JULIAN
TECHNICAL SERVICE BULLETIN # 200

Product: Julian

Re: **Replacement of pressure absorption PCB on the EDOS block**

Figure. 1

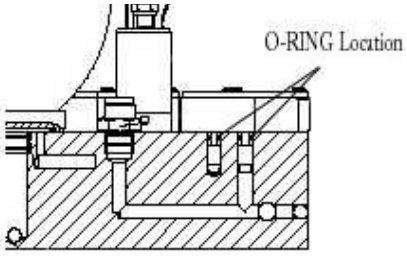
Reason/Rational: To ensure no leaks in the EDOS block after replacement of pressure absorption PCB (8201761)

Figure. 1 shows location of o-rings on the pressure sensor ports internal to the EDOS block. Figure. 2 shows the where the o-rings are located on the pressure absorption PCB from the top.

Solution/Procedure: Install o-ring (8410713) on to pressure sensor input / output ports on pressure absorption PCB when replacing in the field. See diagrams below for location of o-rings.
